VIN APPLICATION
ALL with optional
cellular telephone

BULLETIN NO.
93-023

Intermittent Power on Cellular Phone

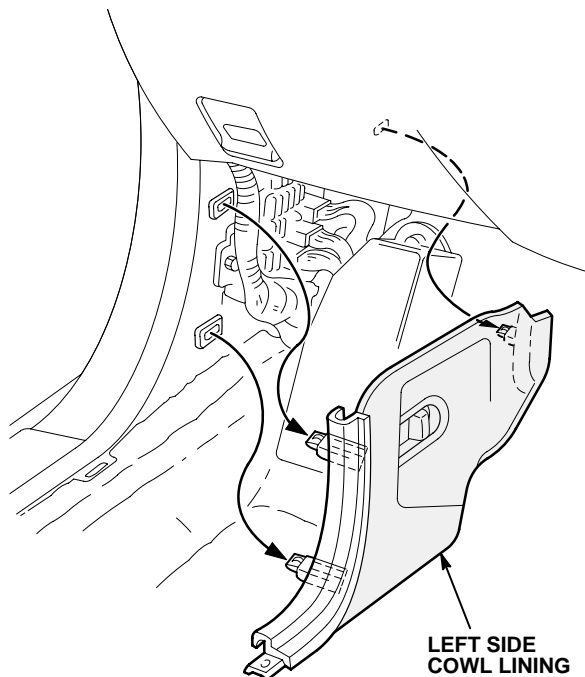
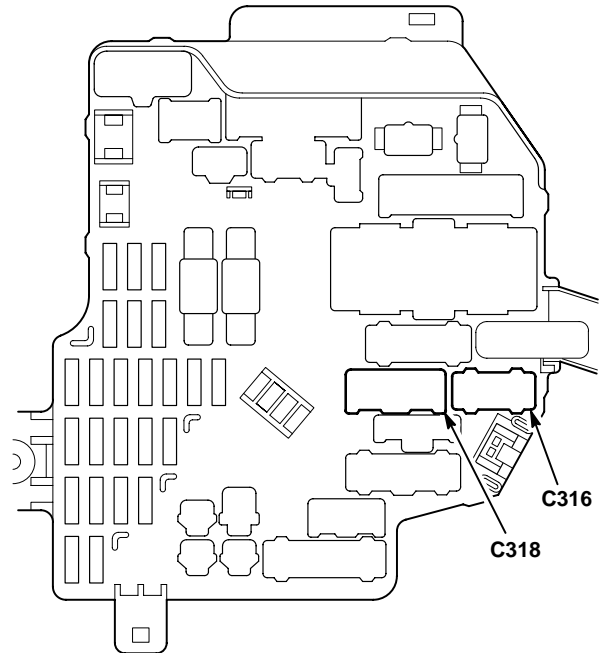
The Acura cellular telephone intermittently fails to power up after starting the engine or fails to maintain operation during starter motor engagement.

Voltage to the cellular telephone transceiver is interrupted when the starter motor is engaged.

Install the sub-diode harness (see PARTS INFORMATION) to maintain voltage to the transceiver during starter operation.

1. Remove the left side cowl lining.

2. Disconnect the 12-P C316 connector in the interior fuse box.

3. Insert the 12-P male connector of the diode sub-harness into the C316 cavity.
 4. Insert the C316 male connector, just disconnected from the fuse box, into the 12-P female connector of the diode sub-harness.
 5. Disconnect the C318 connector from the interior fuse box.
 6. Loosen the terminal retainer on the C318 male connector just enough to insert the loose pin of the diode sub-harness into cavity #6.
- NOTE: Be careful not to pull the retainer all the way out, or you will have to re-thread the connector wires.
7. Push the terminal retainer back in, locking the diode sub-harness pin in place.
 8. Reconnect the C318 connector into the fuse box.

9. Verify operation of the cellular phone during starter operation.
10. Reinstall the left side cowl lining.
